# RUGER-57™ PISTOL PRODUCT SAFETY BULLETIN

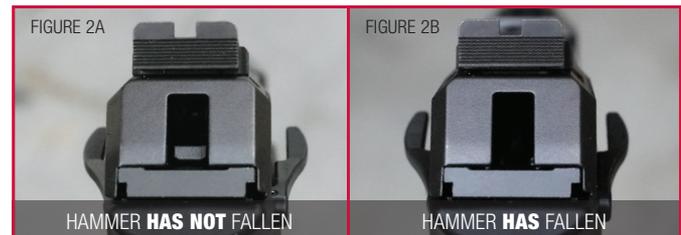
In some rare instances, the internal “leg” of the right safety lever may crack or break, rendering the manual safety ineffective. If present, this condition may cause the manual safety to appear to be functioning properly when it is not. Although Ruger already instructs owners of Ruger-57 pistols to perform a function check before each use, we are requesting that all owners of potentially affected pistols perform this safety inspection immediately.

1. With the pistol pointed in a safe direction, remove the magazine and place the manual safety in the “fire” position.
2. Retract the slide and lock it to the rear using the slide stop.
3. Visually and physically inspect the chamber to ensure there is no ammunition present.
4. Retract the slide slightly and release to allow the slide to close on an empty chamber.
5. Engage the manual safety by pushing up on the safety lever (see Figure 1). Ensure it moves up fully and “clicks” into place.

6. With the pistol pointed in a safe direction, pull the trigger firmly, but do not force it beyond the point where you meet resistance. The trigger should be blocked and the hammer should not fall (see Figure 2A).

**IF, WITH THE MANUAL SAFETY ENGAGED, YOU ARE ABLE TO PULL THE TRIGGER AND THE HAMMER FALLS (SEE FIGURE 2B), OR IF YOU ARE UNSURE, PLEASE DO NOT USE YOUR PISTOL AND IMMEDIATELY SIGN UP FOR THE RETROFIT AT [RUGER.COM/RUGER-57RETROFIT](https://RUGER.COM/RUGER-57RETROFIT) OR BY PHONE AT 336-949-5200.**

**STEP 1:** If your pistol fails the function check listed above (you are able to pull the trigger and release the hammer with the manual safety engaged), please do not use your pistol, and sign up for the retrofit at [Ruger.com/Ruger-57Retrofit](https://Ruger.com/Ruger-57Retrofit) or by phone at **336-949-5200**.

**STEP 2:** Our Customer Service team will issue you an RMA and send you a pre-paid shipping label to return your pistol for service.

**STEP 3:** We will perform all required safety updates and will make every effort to return your pistol within one week of when we receive it.
